URBAN CORE SPECIFIC PLAN

Advisory Committee - March 16, 2005

Meeting Summary

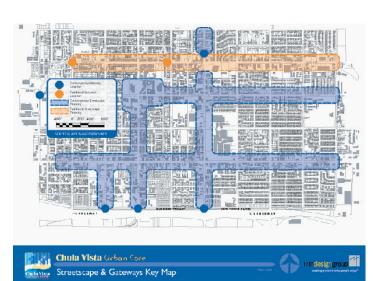
- Consider moving the 4th Avenue gateway to E Street instead of C Street
- Use less of a comprehensive theme, be more eclectic – don't want to be "Disney-like"

- Extremes of traditional and contemporary could be conflicting – tie more closely together
- Consider J Street as a gateway
- 3rd Avenue treatment should be more upscale, not quite as traditional

- · Consider some Art Deco influences
- Look at the branding efforts by the Downtown Business Association for 3rd Avenue
- Aranch or early California theme is more appropriate than a mission theme – perhaps lemon groves

- Use a kite, flight, wings, or bird theme that reflects Chula Vista being in the Pacific fly away and destination for birders
- Sails are not appropriate as the adjacent bay is too shallow for sailing and San Diego already uses a similar theme for the convention center

- It is important for the 4th Avenue gateway to remain at C street, the historic gateway to the City
- Reinvent Chula Vista based on its unique characteristics

- Contemporary treatment is forward thinking, looking to Chula Vista's future

Erik Justesen provided a recap of the Committee's comments. The contemporary treatment is generally appropriate for areas other than 3rd Avenue which merits differentiation and explore a more unique identity for gateways.

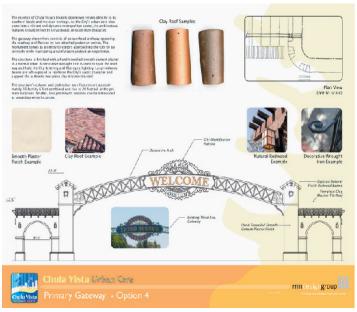
- Make 3rd Avenue welcoming, place parking areas behind buildings
- Fewer lanes are better on 3rd Avenue, could also narrow lanes from 14 feet in width and reduce paved area
- Eliminate parking between E Street and F Street
- Provide some parallel parking on H Street
- Reduce lane width on Broadway from 14 feet
- Reduce the amount of transit on 3rd Avenue fumes are incompatible with dining
- More pedestrian area on 3rd Avenue would be great – perhaps create use for pedestrian area exclusively?
- Consider diagonal parking and wider sidewalks on Broadway
- Like the use of trees to buffer traffic
- Use caution in eliminating parking in the near term

phase reductions/relocations of parking to reduce impacts to retailers
- Take all parking off of 3rd Avenue
- Widen sidewalks to allow opportunities for art displays
- Use parking districts to address parking
- People make an area vital
- Provide signage to direct people to parking
- Discourage use of parking meters they are not profitable and discourage people from staying
